News 2006/10

Sales Information: New Trouble Indication for NUK-HP Switchboard

GekaKonus GmbH delivers from the 01.01.2006 for all new orders the switchboard for the High Pressure Steam Boiler type NUK-HP with a new Trouble Indication type Siemens- LOGO.

Old Trouble Indication

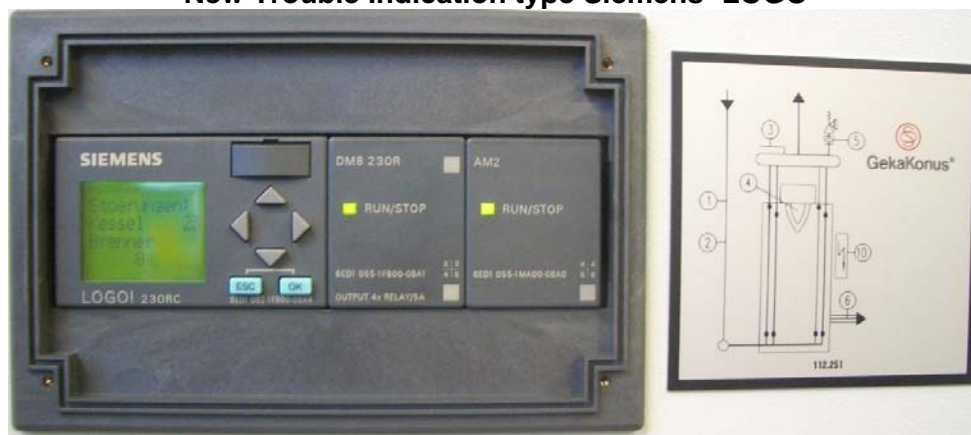
New Trouble Indication type Siemens- LOGO

1. 4- lines display with scroll function for improving of visual description of the individual fault messages
2. Indication of the date and time
3. Integrate operation time counter for burner
4. Registration of the burner and boiler troubles
5. Duplication of the occurred troubles
6. Better trouble shouting and removal
7. Indication of the flue gas temperature
